7 COMMENTS AND RESPONSE

7.1.1 Response to Agency Comments on the DEIS

Please reference the Draft Environmental Impact Statement (EIS) for the Springdale Northern Bypass, Docket No. FHWA-AR-EIS-01-01-d.

Springdale Master Street Plan

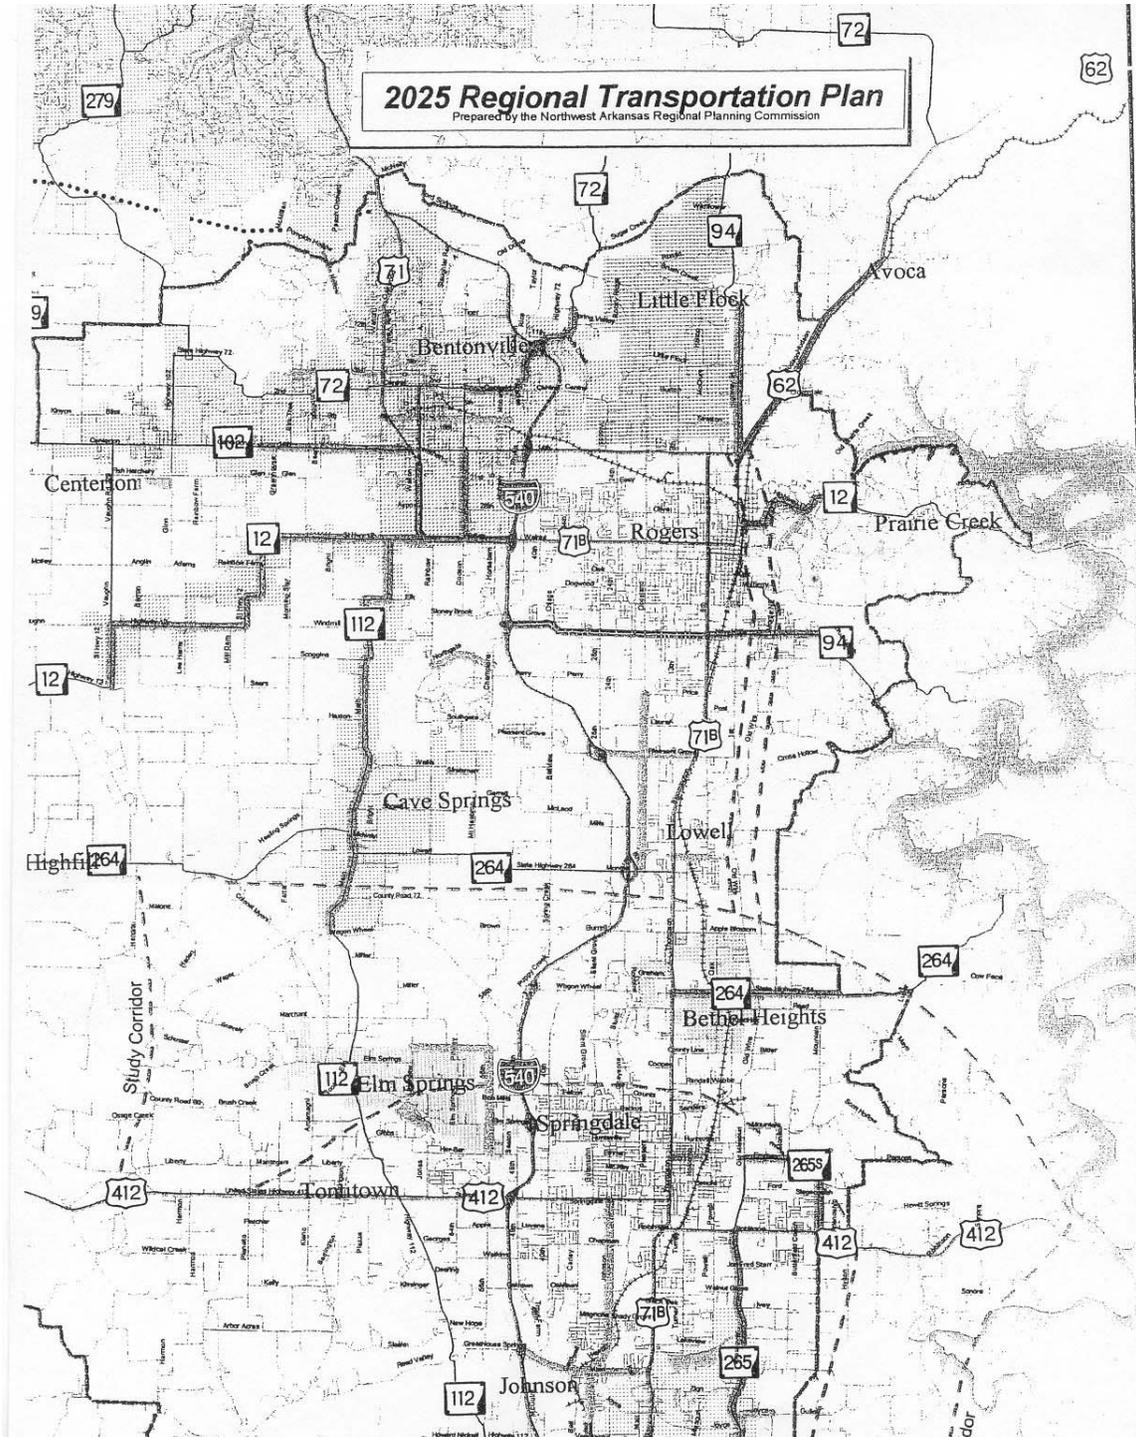
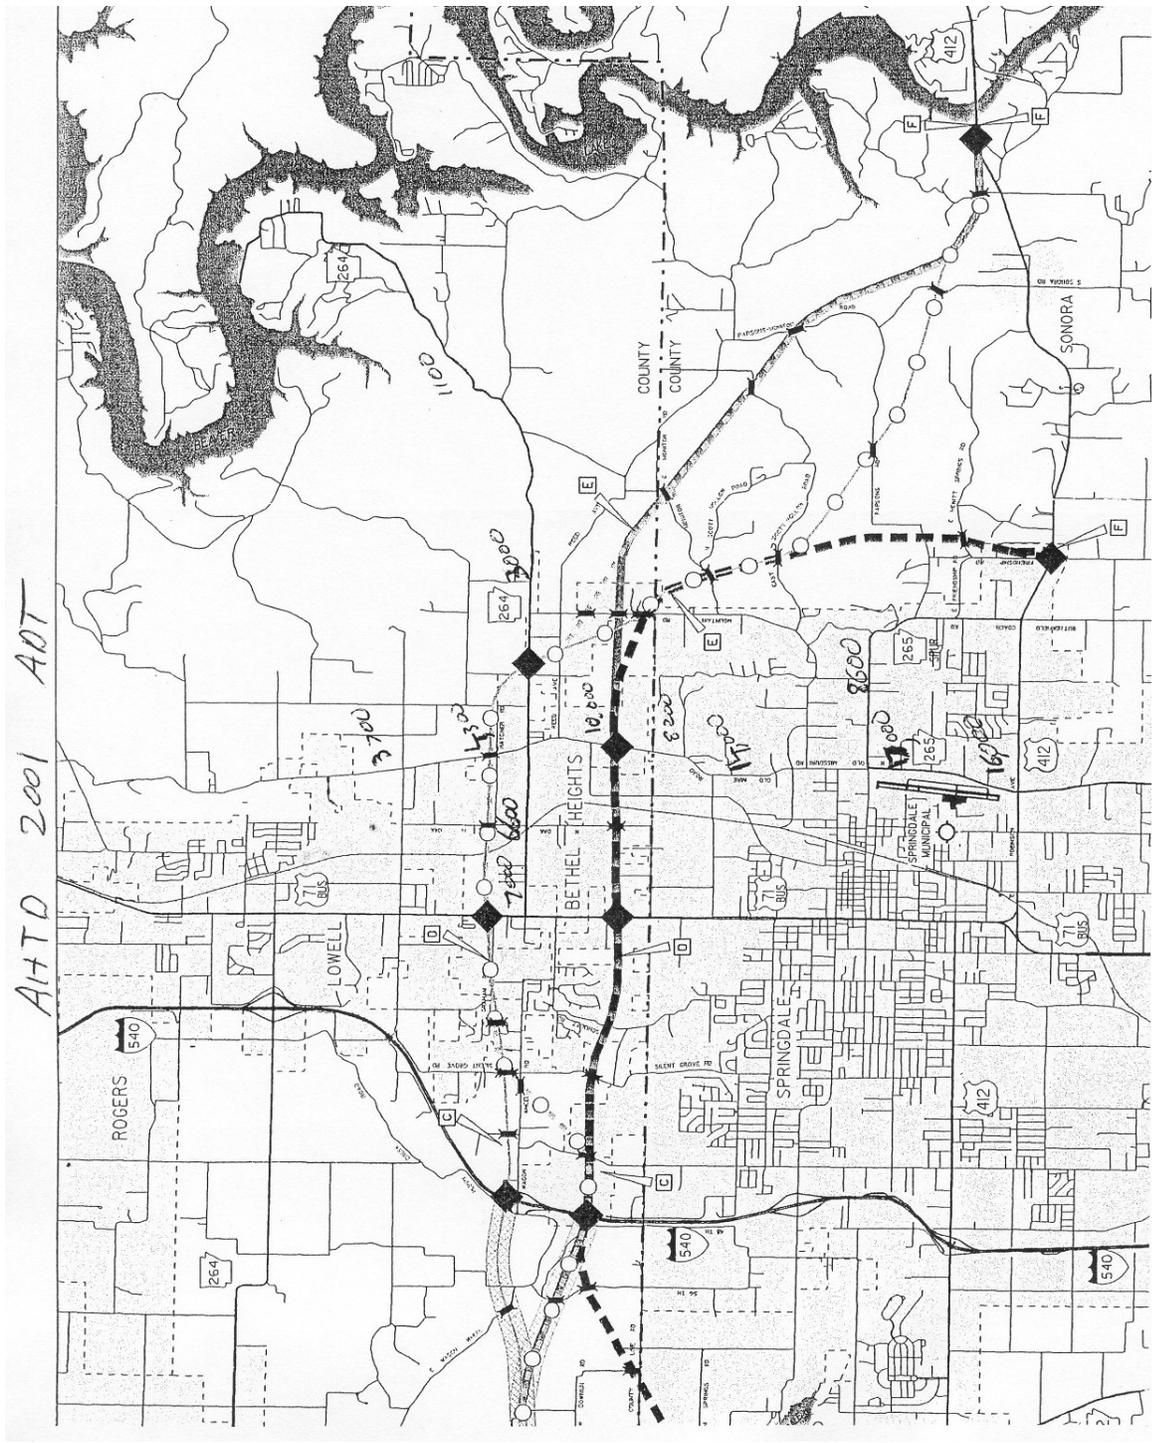
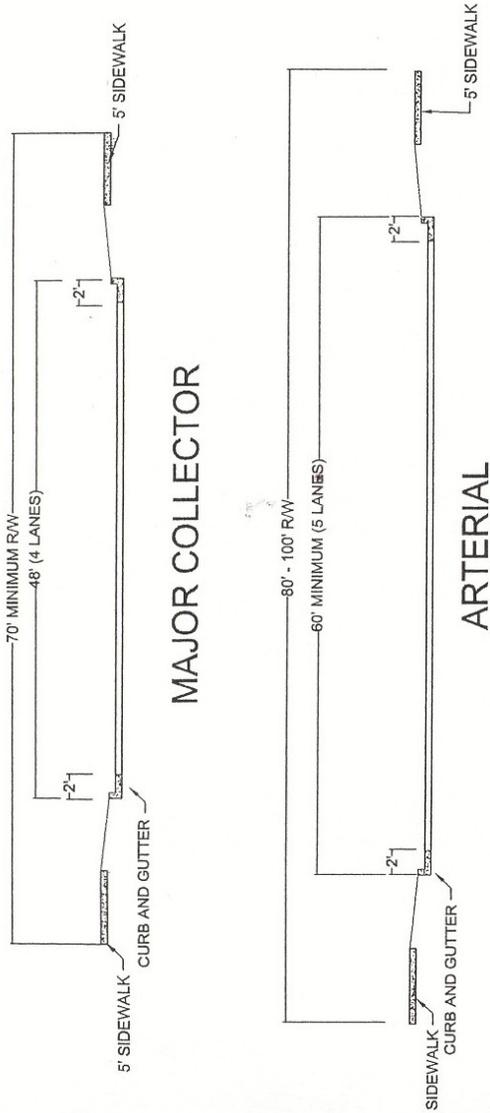
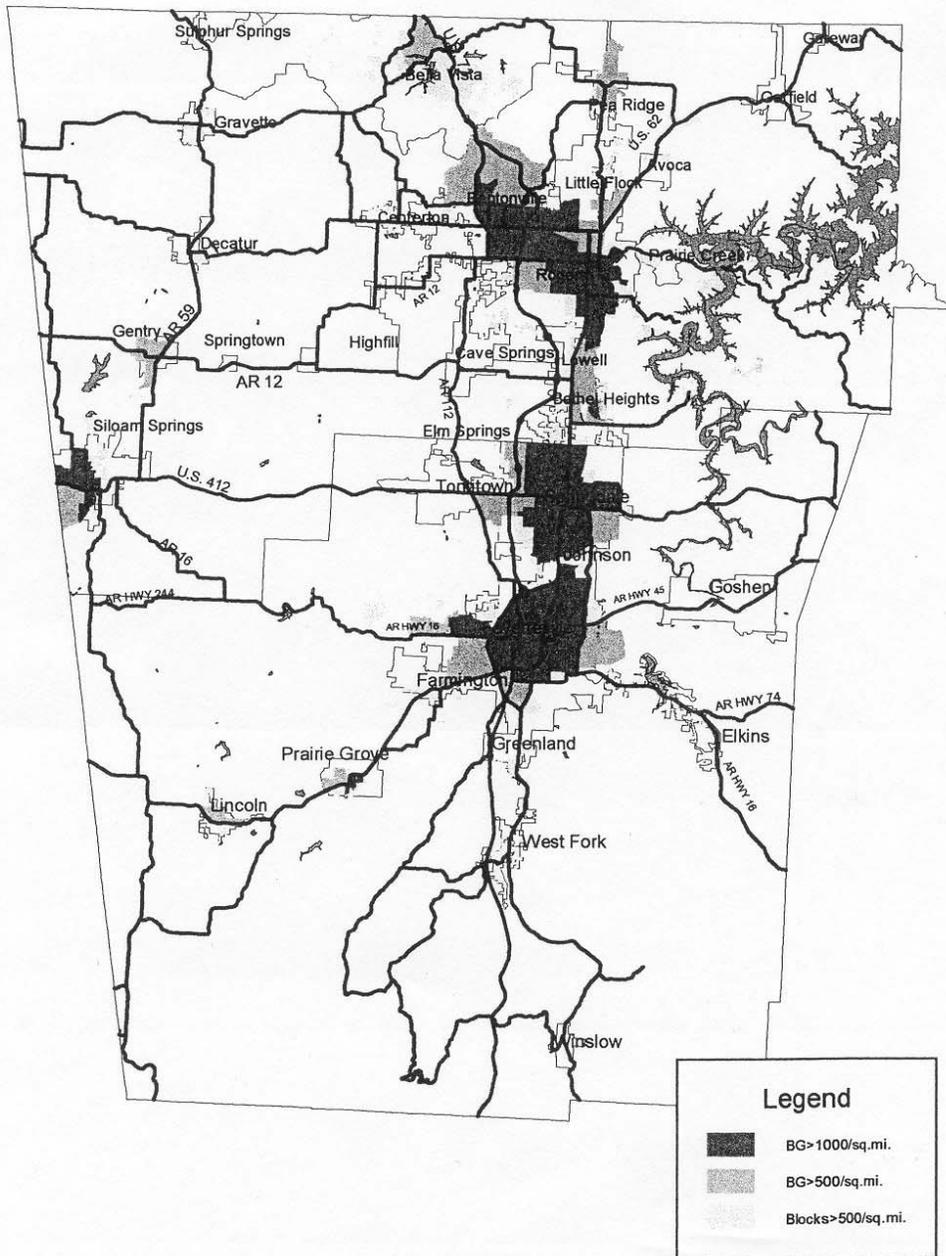
We are proposing that the interchange on State Highway 264 be moved to the Old Wire Road. The Major Investment Study that established the Northern Bypass Corridor also established a corridor to the east of Lowell and Rogers following the Old Wire Road. This Old Wire Road Corridor is on the Regional Long Range Plan (attached), and will link northeast Springdale with the eastern side of Rogers. This corridor is a northern extension of State Hwy 265, a facility that is planned to be four/five lanes from Hwy 16 in Fayetteville to its northern terminus in Springdale. An interchange is clearly needed where this 265/Old Wire corridor crosses the proposed Northern Bypass.

Springdale's master street plan shows the 265/Old Wire corridor as a Principal Arterial all the way up to and beyond its northern city limit thus intersecting with the Northern Bypass. Springdale's master street plan shows Principle Arterials as five lane facilities. Even though the 265 designation ends at Emma Ave, the Springdale portion of the 265/ Old Wire corridor is a four-lane facility to the Randall Wobbe Road in Springdale. Future plans (unfunded) call for four/five lanes up to and beyond the Northern Bypass.

Response: The bypass interchange was moved from Hwy 264 to Old Wire Road (Highway 265) in the SDEIS and FEIS.
